## INSTRUCTION TO SERVICE

<b>ITS: 6266</b>	
<b>SECTION:</b>	294 Power Cables
<b>WRITTEN BY:</b>	Alan Mark
<b>SUBJECT:</b>	Inspect and Re-torque Ground Power Cables

# ITS6266

**Figure 2: Brake resistor and roof auxiliary container ground point on street side**

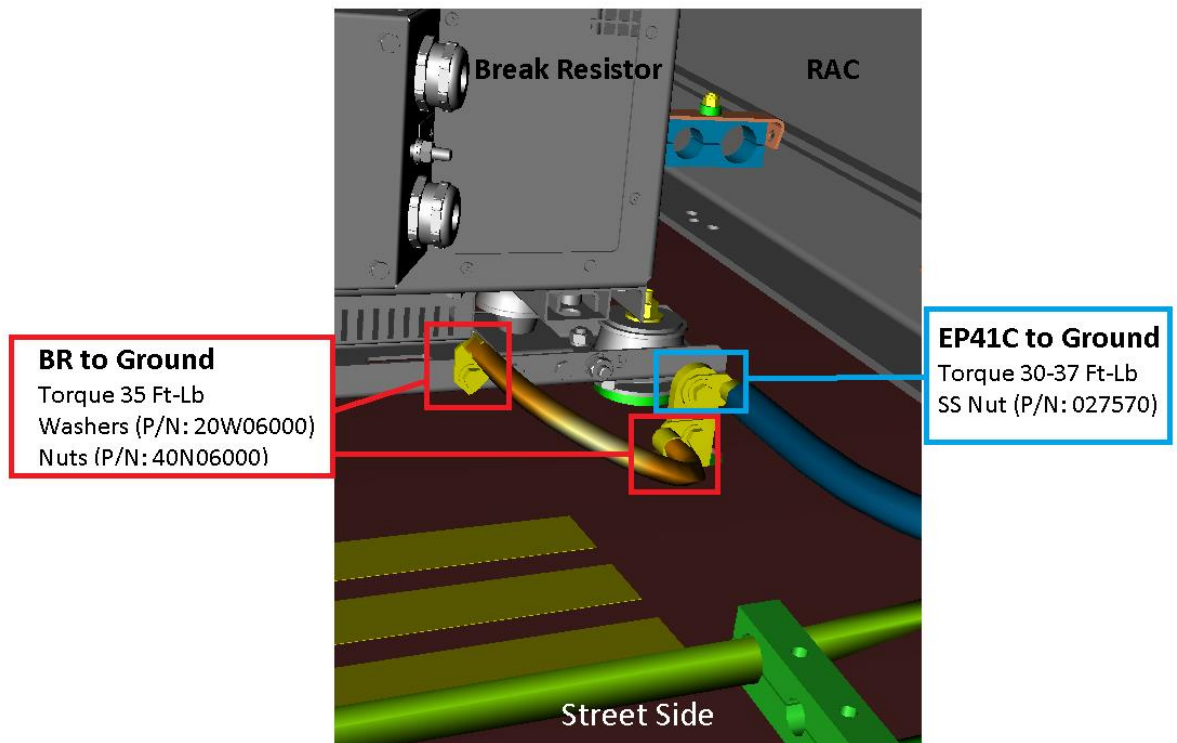
3. Clean off all dielectric grease from the ground bar, cable lugs, and mounting hardware.
4. Locate the BR and EP41PC RAC to ground shown in Figure 2.
  - a. The BR to ground will be reassembled using the existing bolt and the addition of two washers (P/N: 20W06000) and a new lock nut (P/N: 40N06000) and torque to 35 ft-lb as shown in Figure 2 and Figure 8.

- b. EP41RC to ground will be reassembled using the existing washers and bolt but with a new stainless steel lock nut (P/N: 027570). Torque to 30-37 Ft-Lb.

Figure 3: RAC to ground & RTC to ground

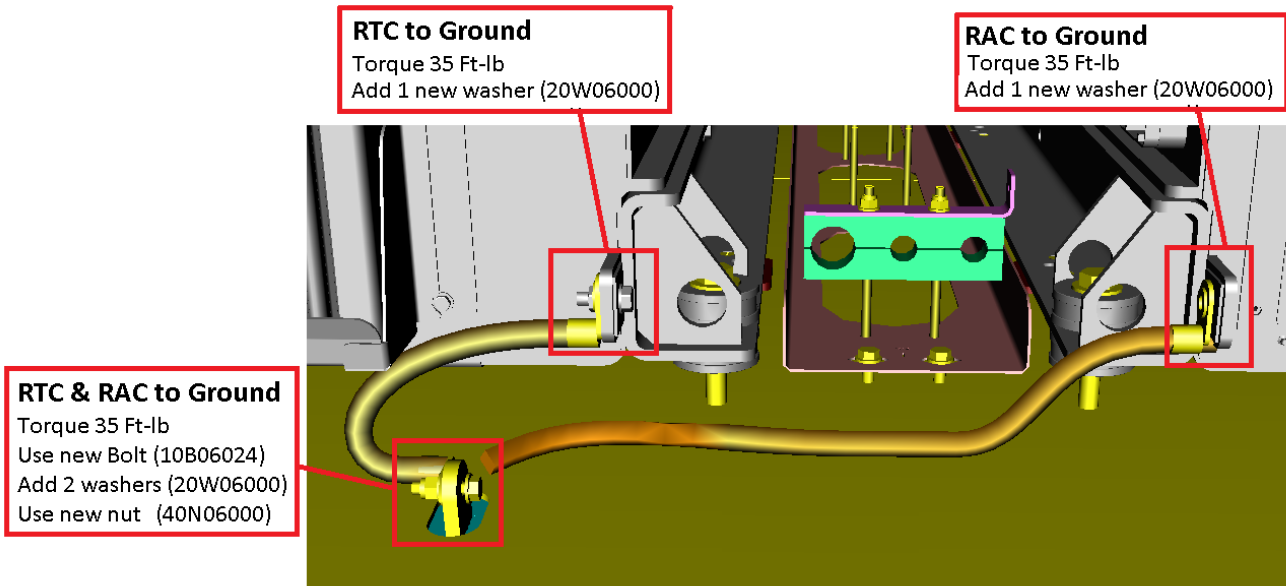
5. Locate the RAC to Ground and RTC to ground as seen in Figure 3.
  - a. Reassemble the hardware using a new 1 1/2" long bolt (P/N: 10B06024), two washers (P/N: 20W06000) and a new lock nut (P/N: 20W06000) as seen in Figure 8. Torque to 35 Ft-Lb.

- b. Reassemble the hardware with the addition of 2 new washers (P/N: 20W06000), one washer per bolt where the ground cables connect to their respective units (RAC and RTC). Figure 3 displays the hardware to use and Figure 8 displays the configuration of hardware.

Figure 4: Brake resistor ground point on curb side

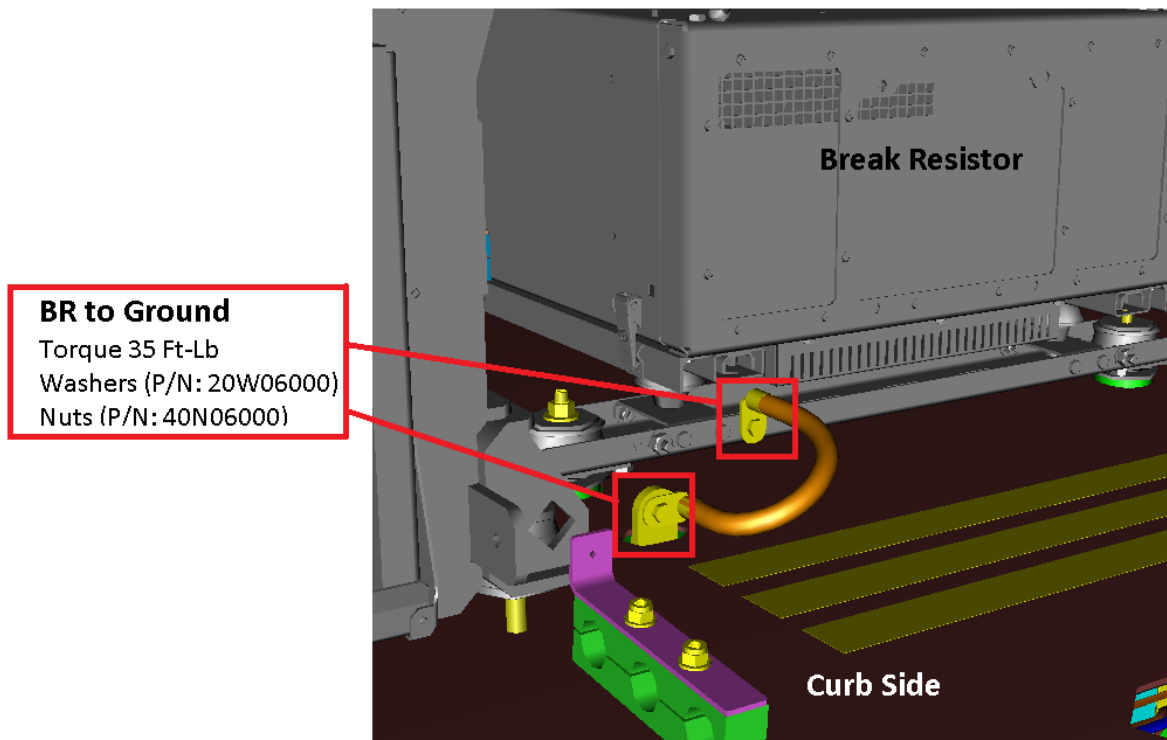
6. The ground locations in Figures 4 to Figure 7 can be reassembled with the existing bolt, new washers (P/N: 20W06000) and a new lock nut (P/N: 40N06000). Figure 8 displays the hardware stacking configuration. Torque these locations to 35 Ft-Lb.

**Figure 5: Rear DGG to ground from curb side**

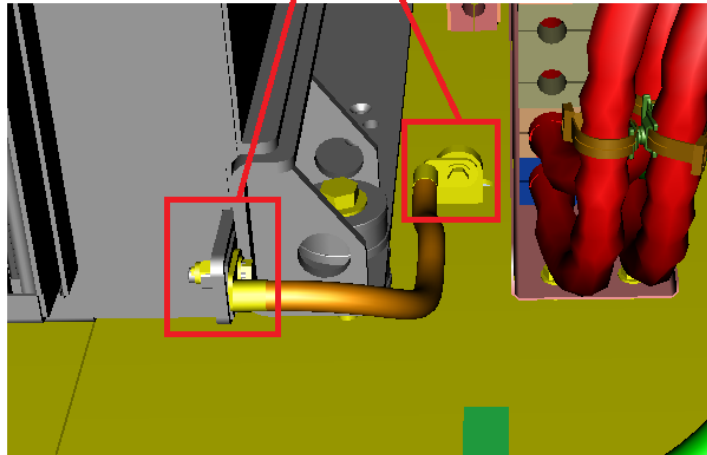
**Rear DGG to Ground**  
Torque 35 Ft-Lb  
Add washers (20W06000)  
Use new nuts (40N06000)

**Figure 6: OSA to ground from curb side**

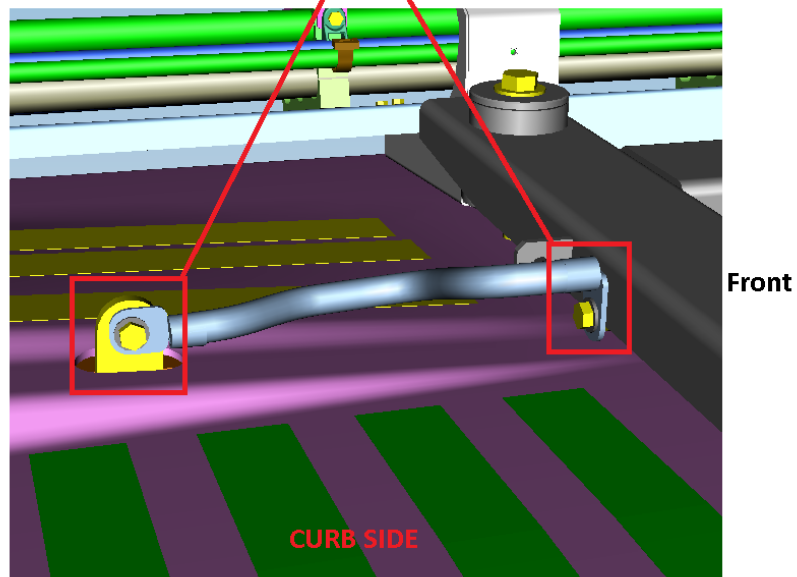
**OSA to Ground**  
Torque 35 Ft-Lb  
Add washers (20W06000)  
Use new nuts (40N06000)
